**FRIENDS
OF THE
RIVER**

April 29, 2005

Re: Comments on Battle Creek Restoration Project SEIS/REIR

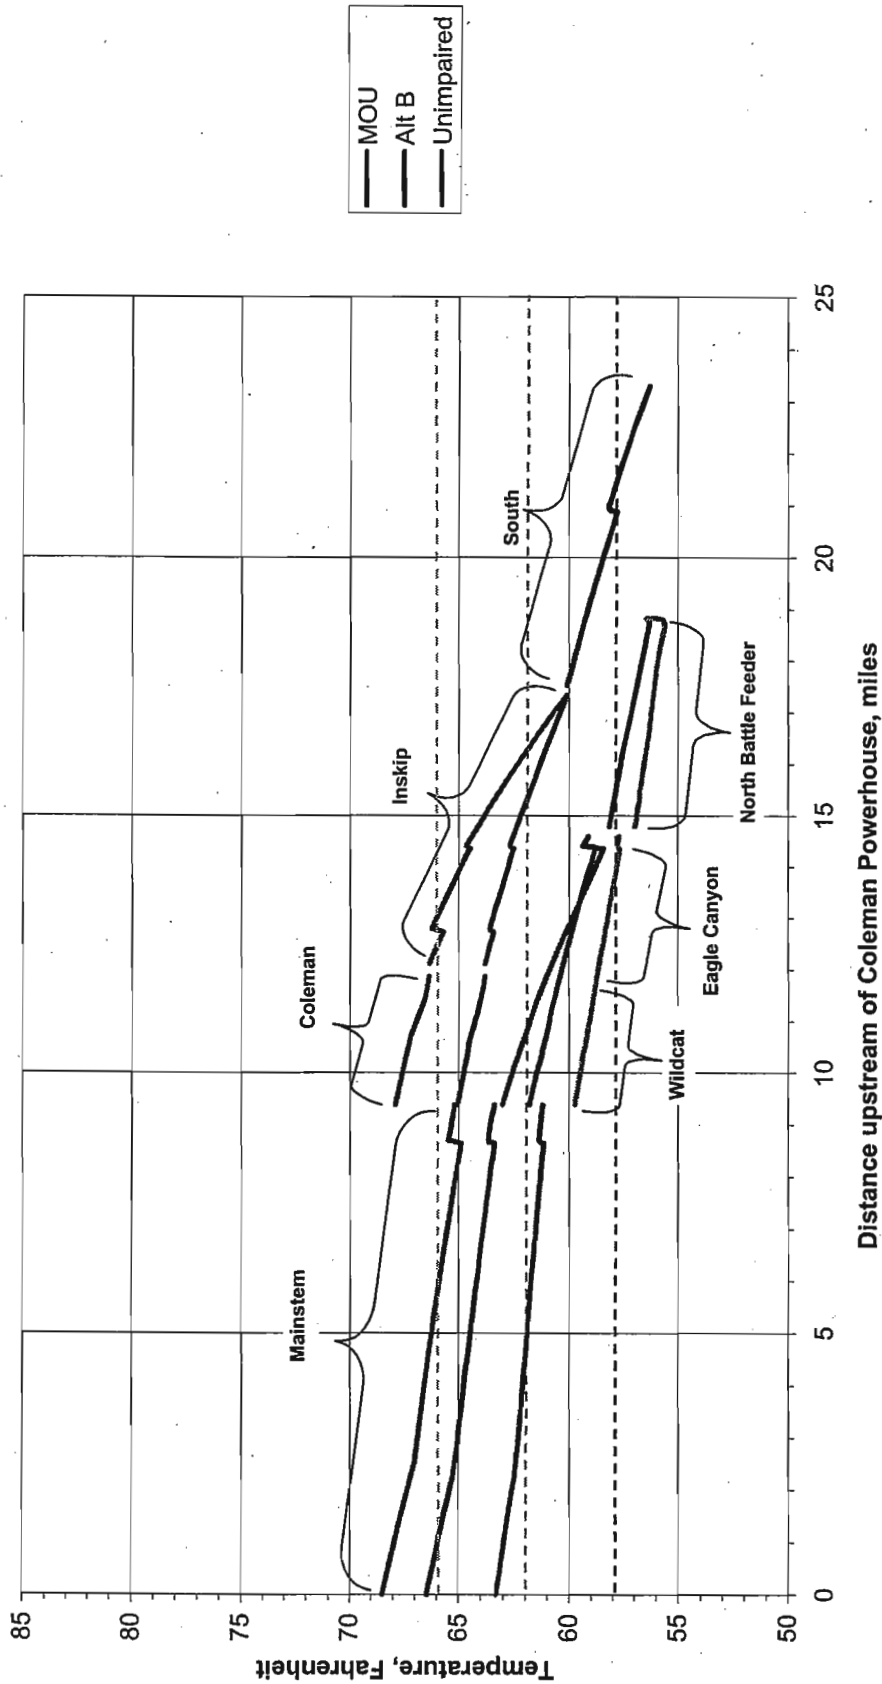
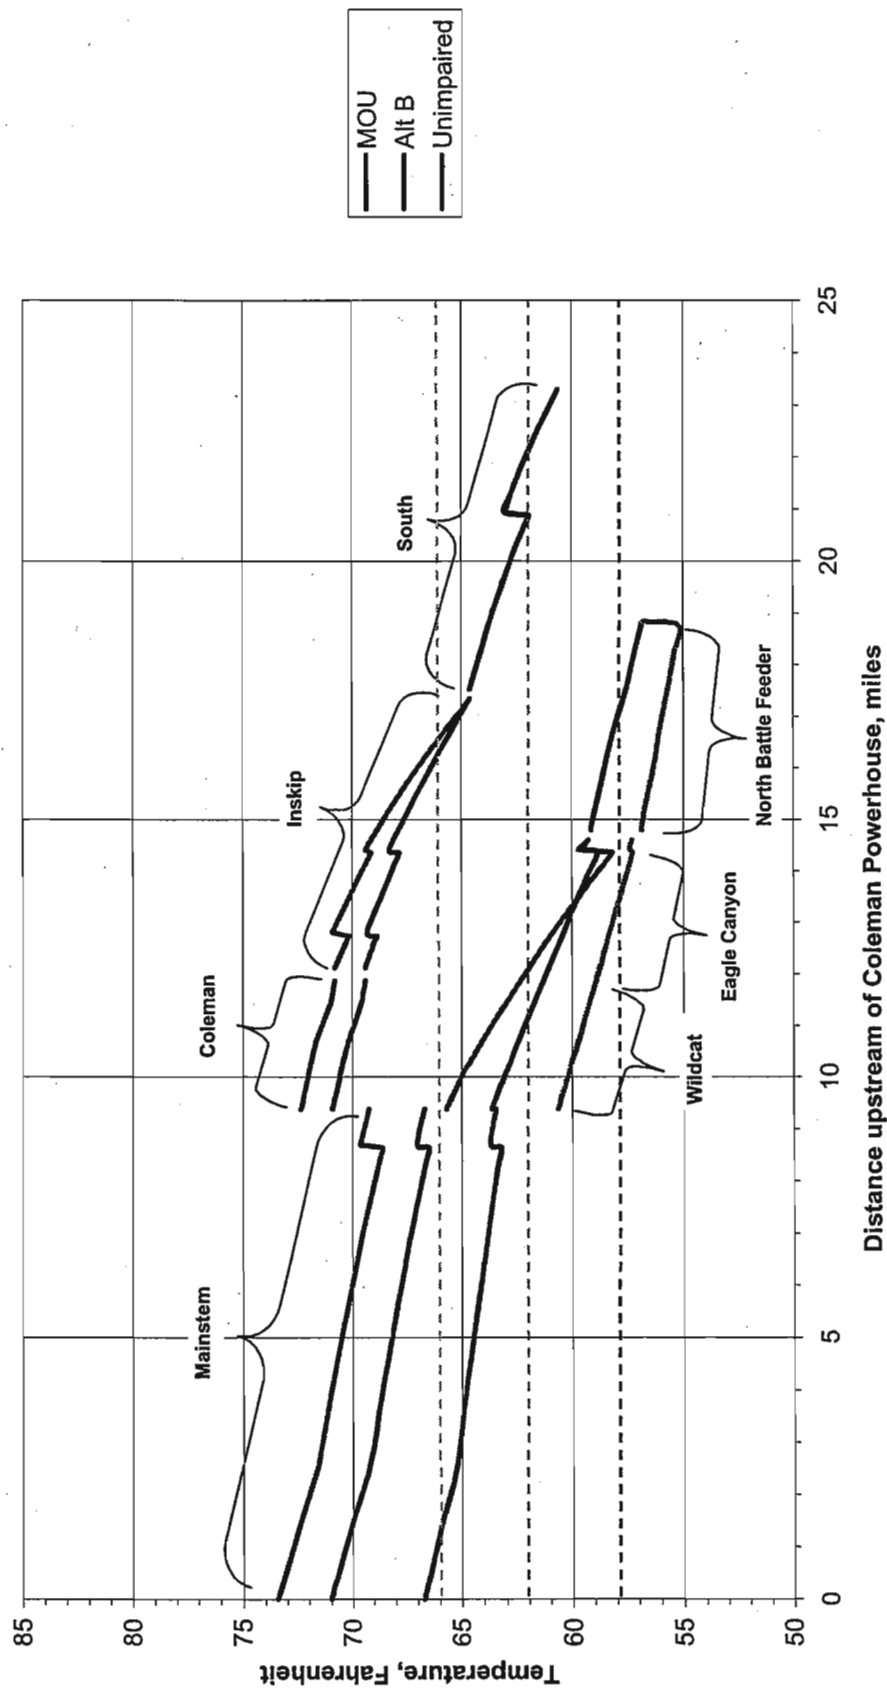
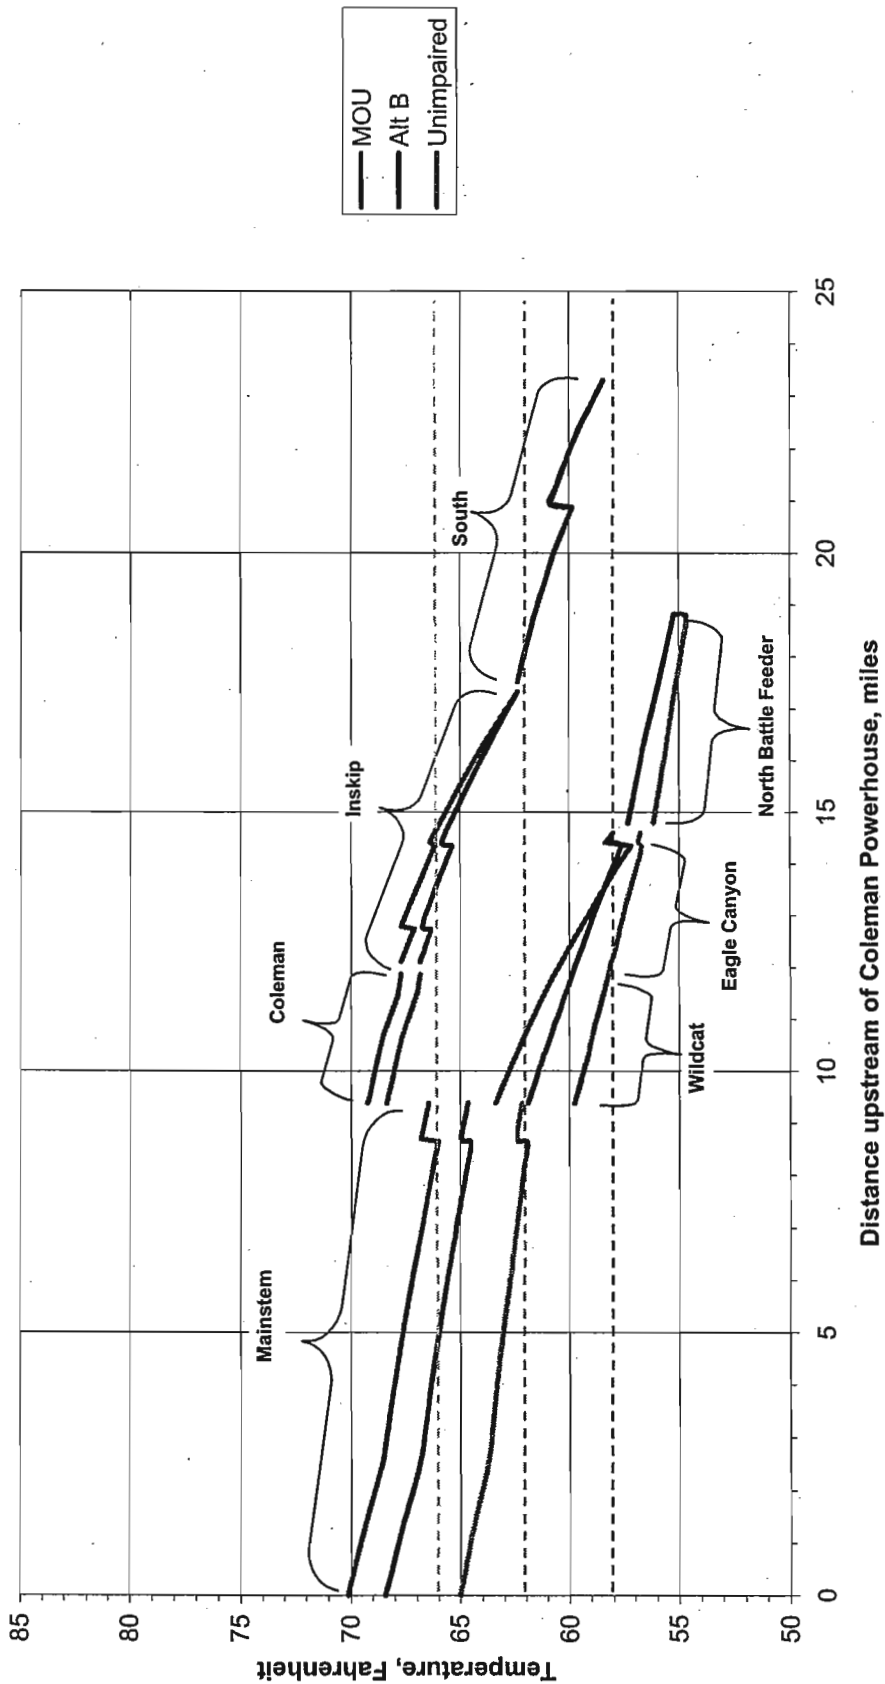
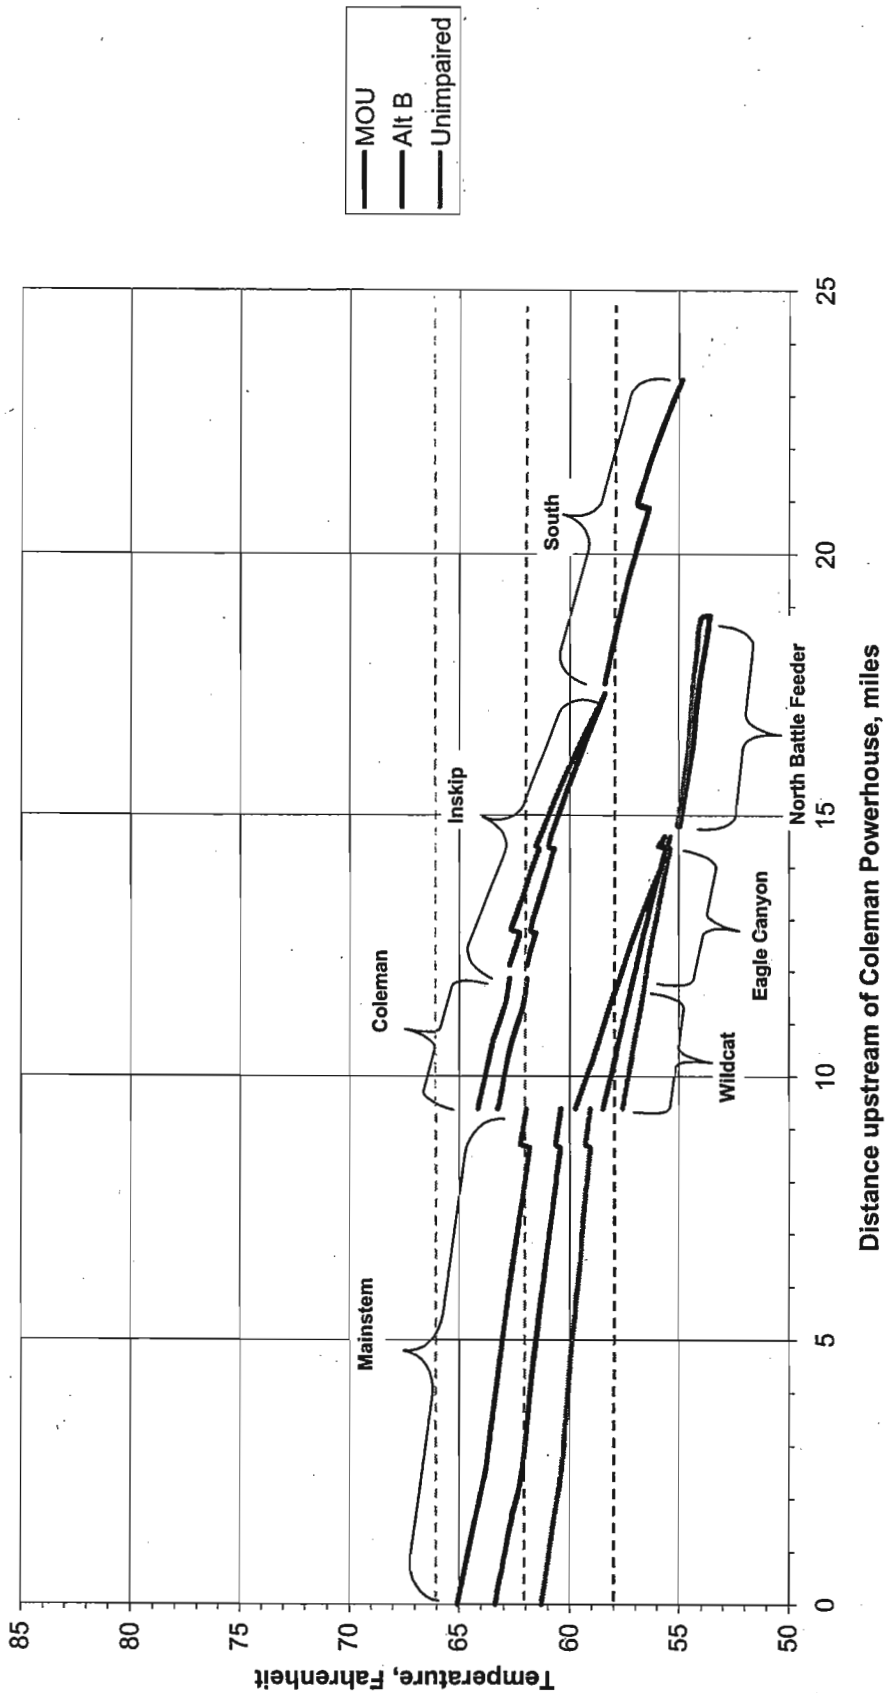
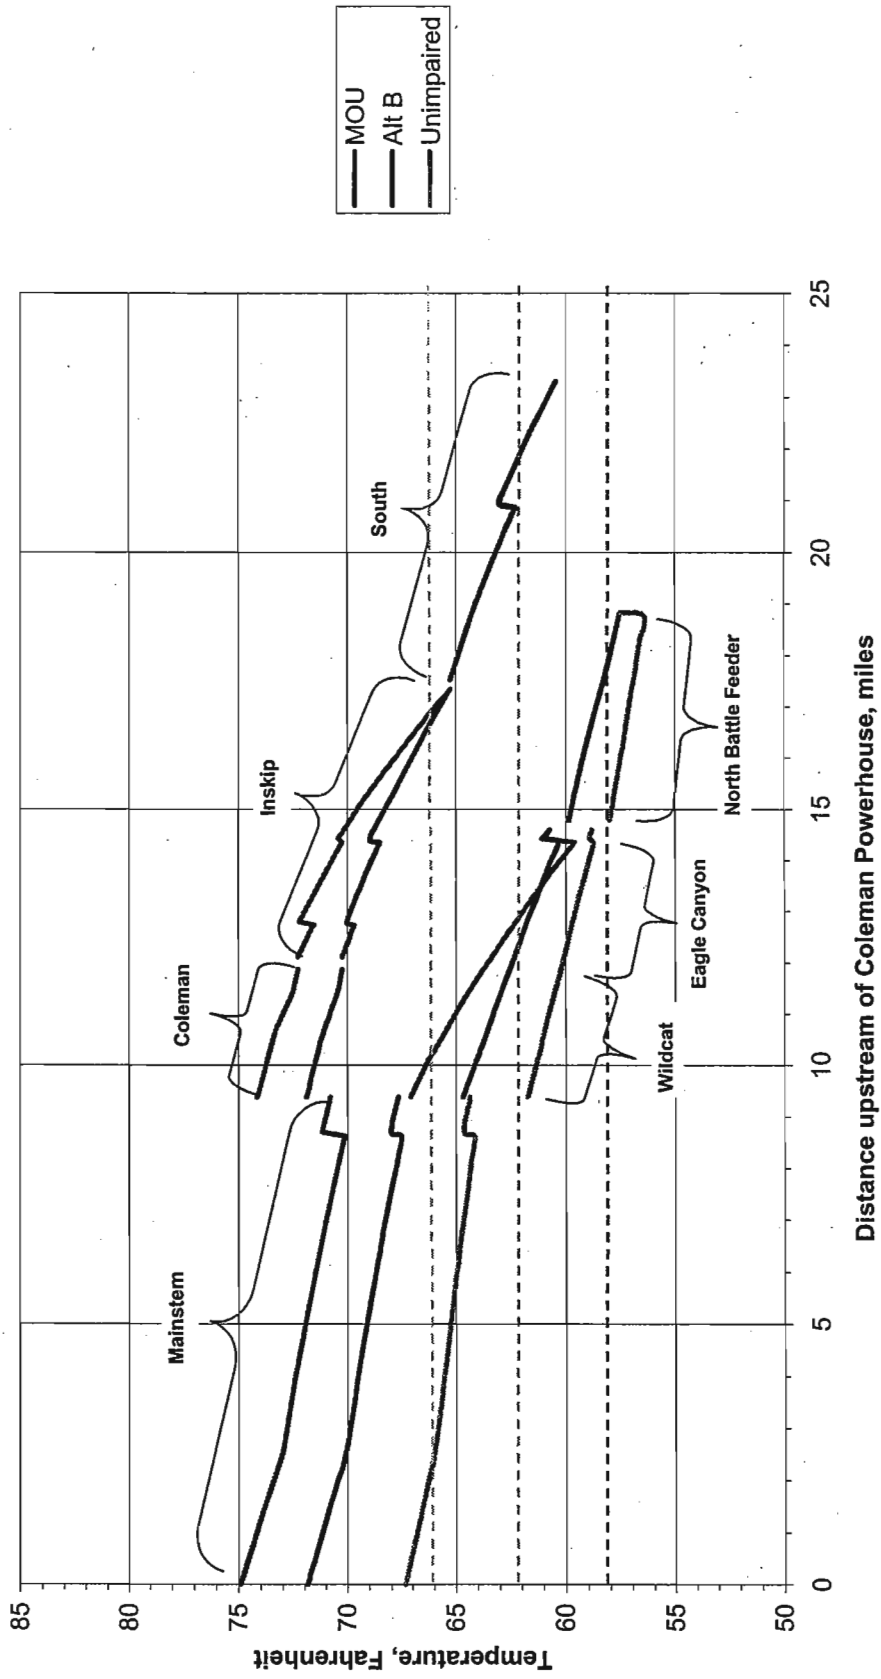
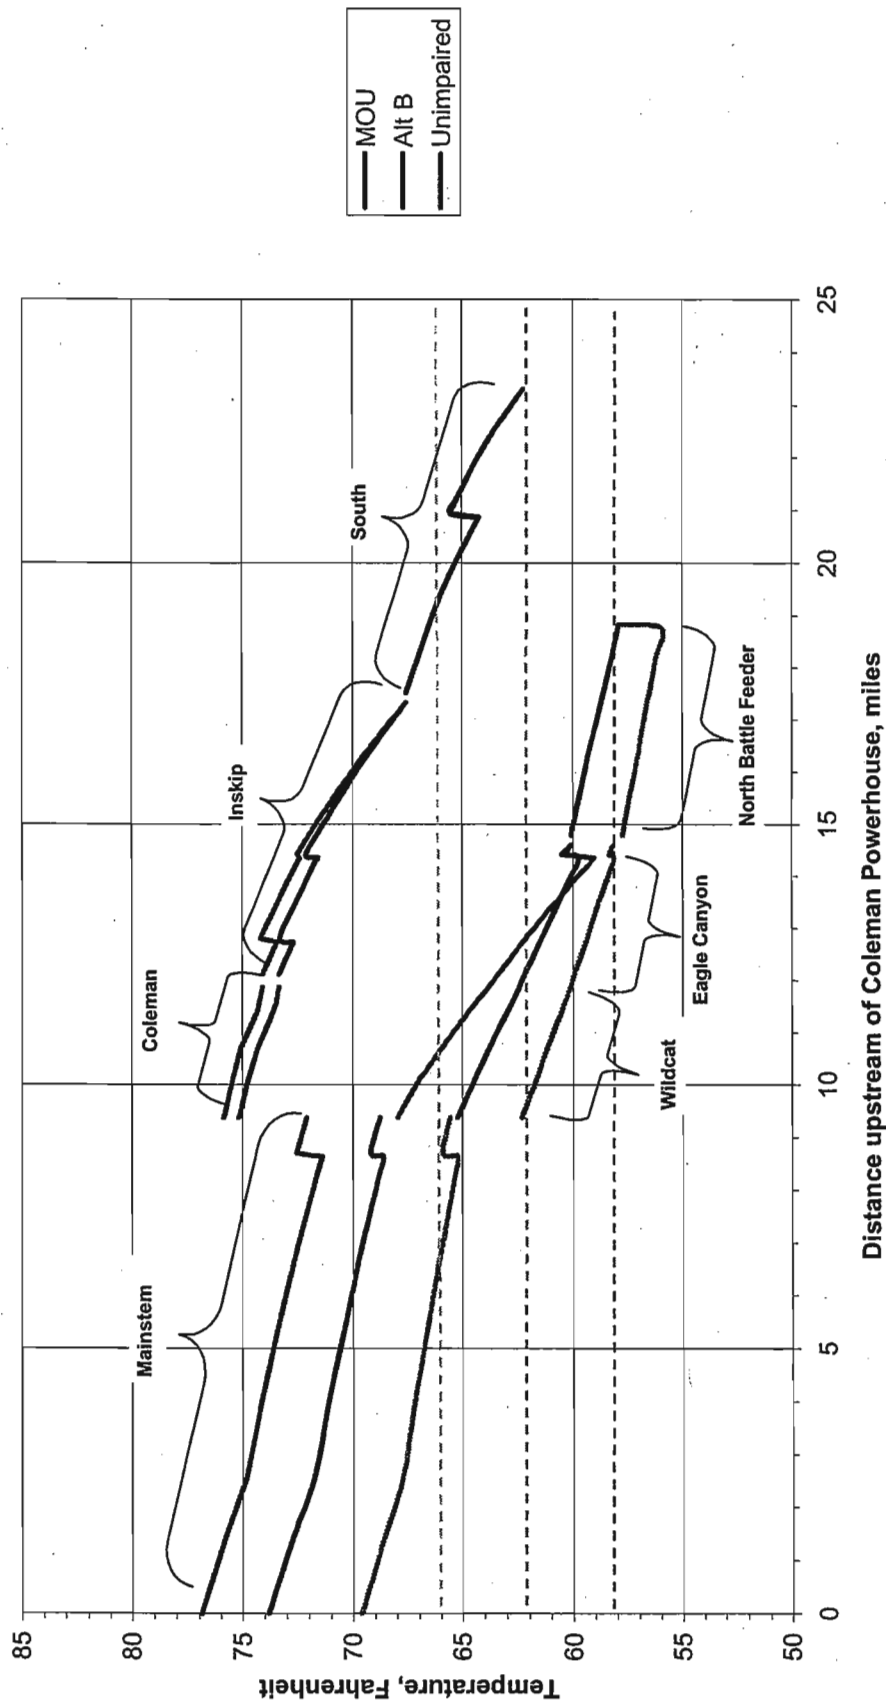
Figures T-1 to T-8 show that Alternative B is predicted to provide cooler water than the MOU in the North Fork, South Fork, and mainstem Battle Creek in all months, for both normal and warm/dry years. Various life stages of four races of chinook salmon and steelhead utilize Battle Creek each month of the year. Assuming temperature thresholds of 66°F for juveniles, 62°F for prespawning adults, and 58°F for incubating eggs (Armour, 1991), in an average June, Alternative B provides an additional 8.7 miles of rearing habitat in the mainstem and South Fork, and an additional 2.5 miles of adult holding habitat in the forks of Battle Creek. In September, Alternative B provides an additional 8.5 miles of adult holding habitat in the mainstem and South Fork Battle Creek and 1.3 miles of egg incubating habitat in the North Fork.

These results are conservative. As described in detail in the following paragraphs, limitations presented by the "hybrid" approach to modeling Alt B, and the flow assumptions of SNTEMP itself combine to significantly understate the temperature benefits of the 8 dam removal alternative. Corrected, SNTEMP would show even greater temperature benefits to Alternative B.
